# UNITED STATES PATENT AND TRADEMARK OFFICE

10/594,319

### Office Action Summary

### **DETAILED ACTION**

Smith et al. discloses:

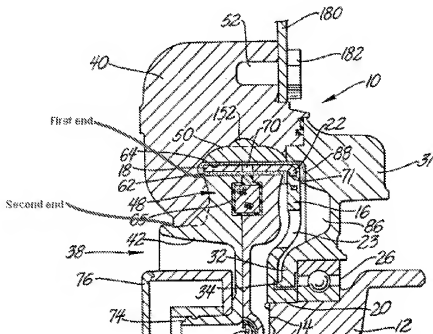
A viscous fluid clutch (see figure 1) comprising:

a housing (31, 40) including a first housing portion (40) cast around an annular housing insert (42) and a second housing portion (31) connected to the first housing portion and defining a fluid reservoir (86) contained by the first and second housing portions; and

a labyrinth seal path (seal path between 48 and 40) formed between the housing insert and the first housing portion and having a first end (radially outer end of seal path; see figure below) and a second end (radially inner end of seal path; see figure below) such that any fluid entering the labyrinth seal path is returned to the fluid reservoir between the first and second housing portions,

wherein the housing insert forming the labyrinth seal path with the first housing portion is (initially) provided as a singled piece (See the 35 U.S.C. 112, second paragraph rejection above. This limitation is treated as a product-by-process limitation and, as such, is not considered to be limiting. See MPEP 2113.).

**Regarding claim 3**, the first end of the labyrinth seal path is located toward an outer radial end of the rotor assembly and the second end is located toward a central portion of the coil assembly.

**Regarding claim 4**, the housing insert includes an annular locking extension portion (176) configured to interlock the housing insert and the first housing portion.

**Regarding claims 49 and 50**, the labyrinth seal path extends from near an end of a rotor (first end of labyrinth seal path) to a central portion of a coil assembly of the clutch (second end of labyrinth seal path).

In response, the first and second ends are now clearly labeled in the figures above.

In response, in addition to the arguments provided in the previous office action, it is noted that when the structure recited in the reference is substantially identical to that of the claims, claimed properties or functions are presumed to be inherent. See MPEP 2112.01. If there are some structural differences, which permits the first and second

ends of the applicant's seal to communicate with the fluid reservoir, missing in the seal of Smith, then applicant must recite those structural differences in the claim language to distinguish applicant's invention over the prior art.

Moser et al. discloses:

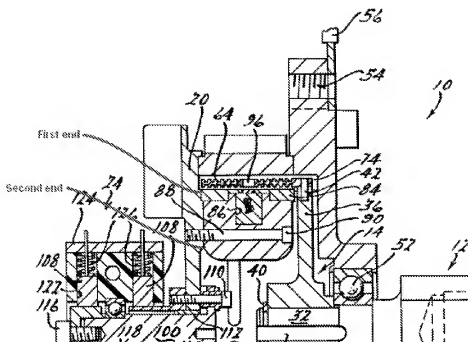
A viscous fluid clutch (see figure 1) comprising:

a housing (16, 18, 20) including a first housing portion (18, 20) provided around an annular housing insert (80, 84) and a second housing portion (16) connected to the first housing portion and defining a fluid reservoir (72) contained by the first and second housing portions; and

a labyrinth seal path (path between 80 and 20; and 84 and 20) formed between the housing insert and the first housing portion and having a first end (radially outer end of seal path; see figure below) and a second end (radially inner end of seal path; see figure below) such that any fluid entering the labyrinth seal path is returned to the fluid reservoir between the first and second housing portions,

wherein the housing insert forming the labyrinth seal path with the first housing portion is (initially) provided as a singled piece (See the 35 U.S.C. 112, second paragraph rejection above. This limitation is treated as a product-by-process limitation and, as such, is not considered to be limiting. See MPEP 2113.).

**Regarding claim 3**, the first end of the labyrinth seal path is located toward an outer radial end of the rotor assembly and the second end is located toward a central portion of the coil assembly.

**Regarding claim 4**, the housing insert includes an annular locking extension portion (leftmost annular portion of 84 which projects beyond the leftmost surface of 80) configured to interlock the housing insert and the first housing portion.

**Regarding claims 49 and 50**, the labyrinth seal path extends from near an end of a rotor (first end of labyrinth seal path) to a central portion of a coil assembly of the clutch (second end of labyrinth seal path).

The examiner respectfully disagrees. Both ends of the seal path of Moser open towards reservoir 72.
